TECHNICAL EVALUATION REPORT
IMPROVEMENTS IN TRAINING AND
REQUALIFICATION PROGRAMS AS REQUIRED BY
TMI ACTION ITEMS I.A.2.1 AND II.B.4

for the
Haddam Neck Plant
(Docket 50-213)

September 1, 1982

Science Applications, Inc.
1710 Goodridge Drive
McLean, Virginia 22102

Figure 5. Personnel Trained in Accident Mitigation.

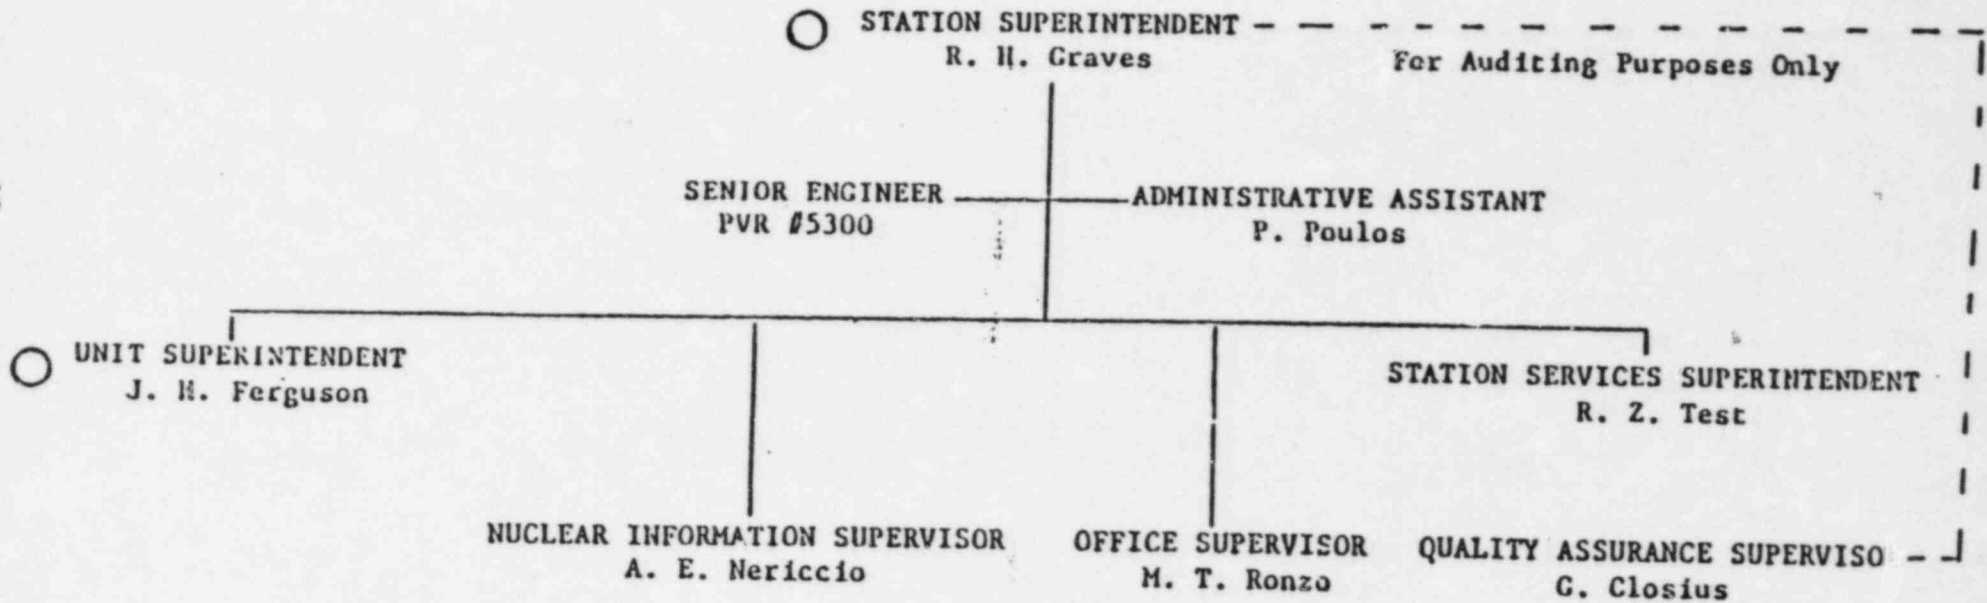
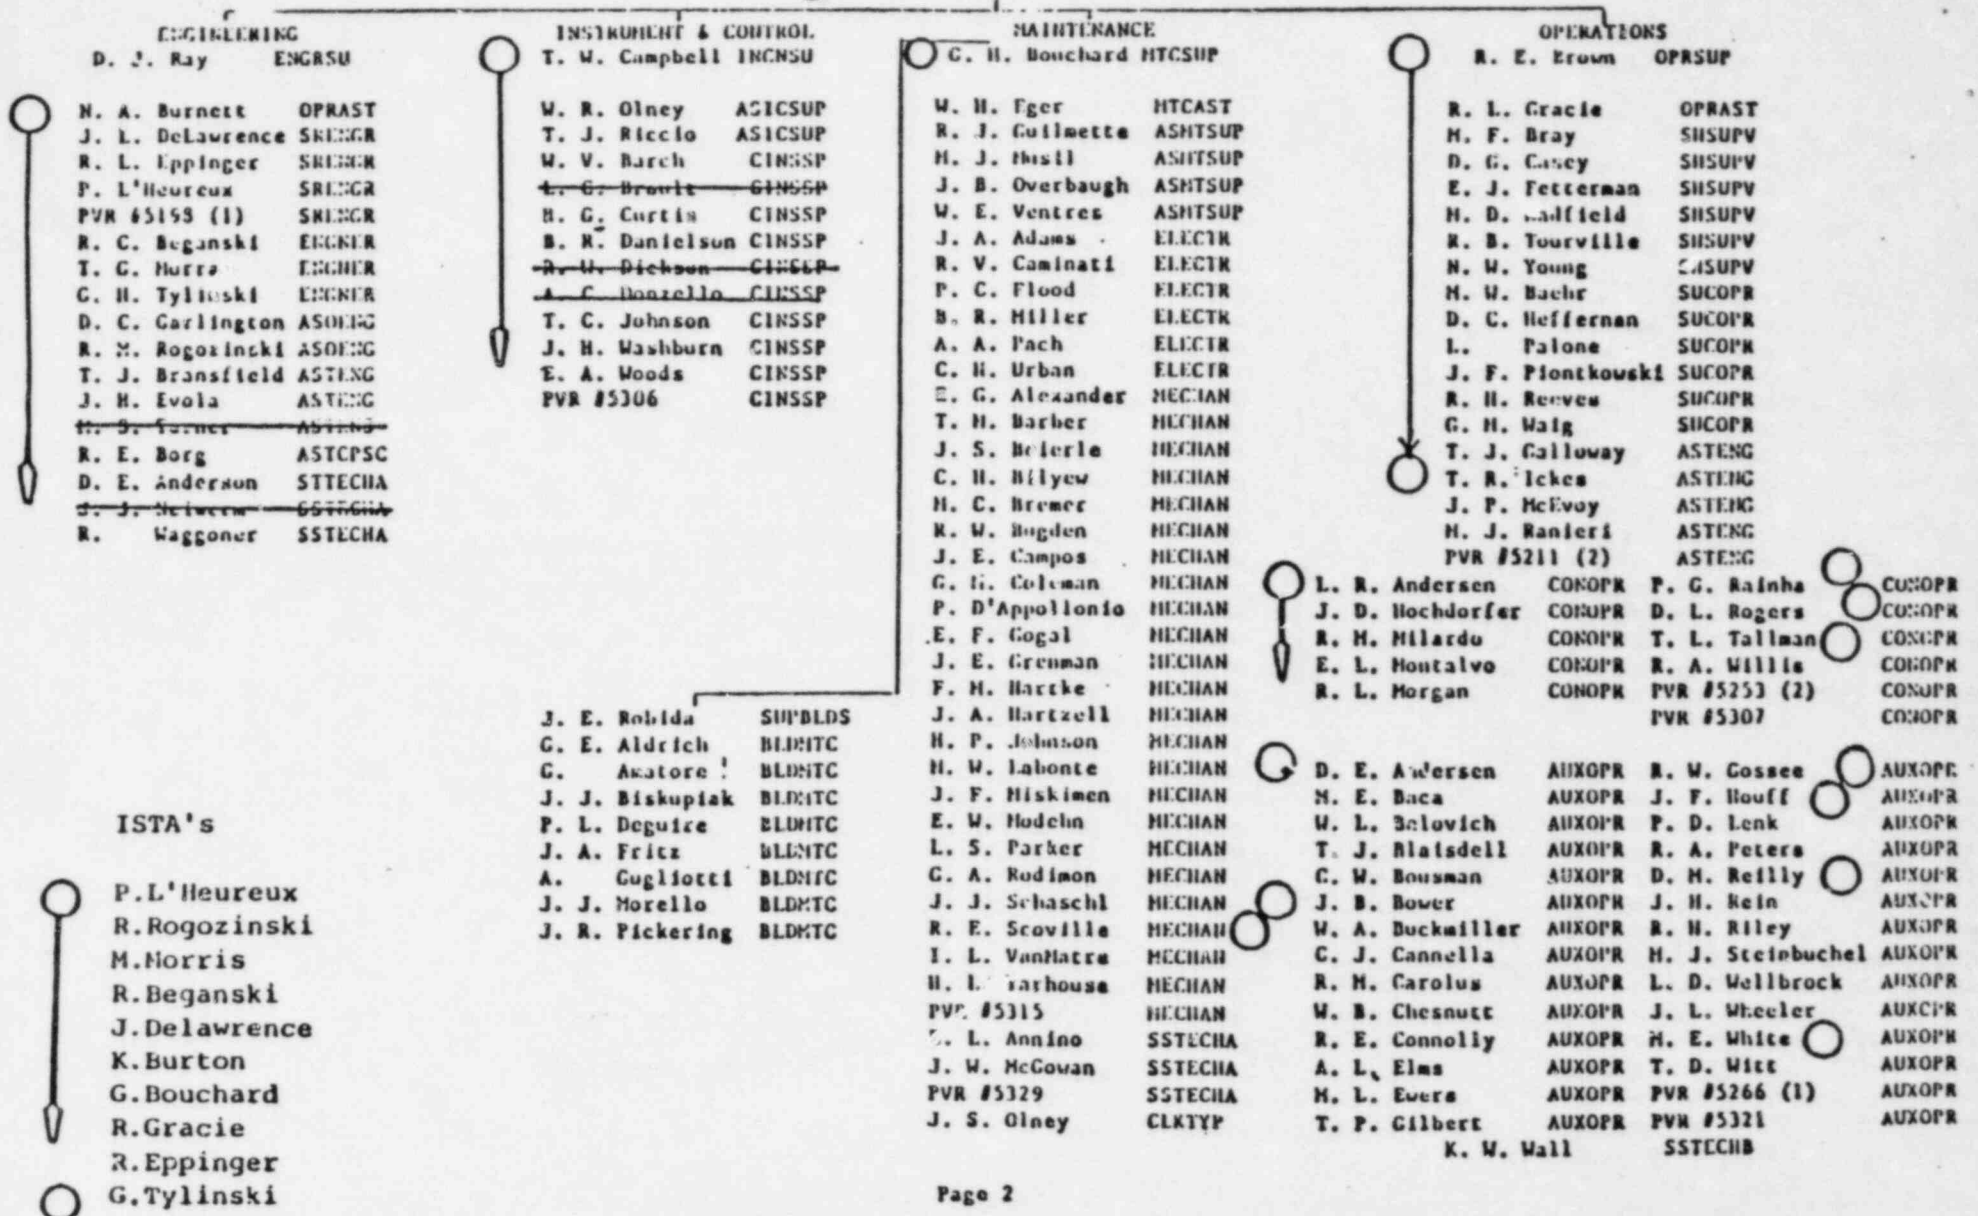
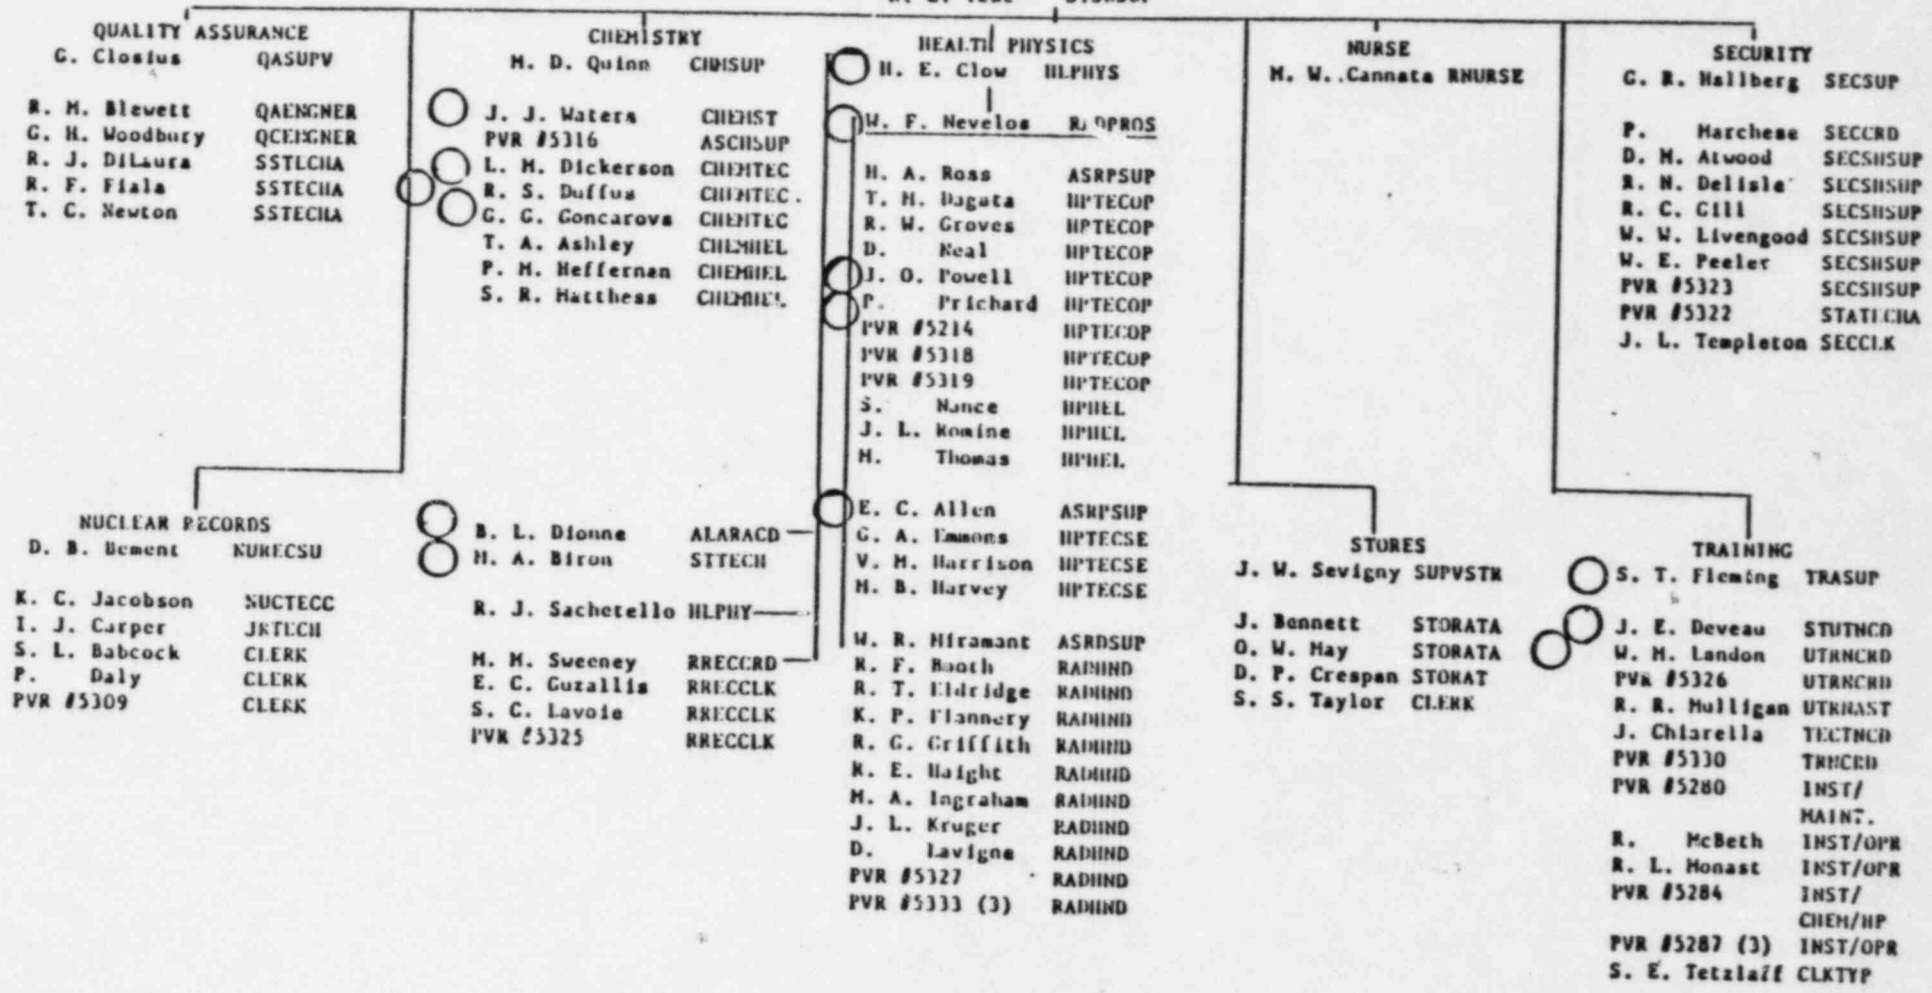
The final criterion associated with training in core damage mitigation is that the course be given all licensed and nonlicensed operations personnel. Submittal Item 8 (Figure 5) provides an identification of the personnel who have received training in core damage mitigation. This final criterion has been met.
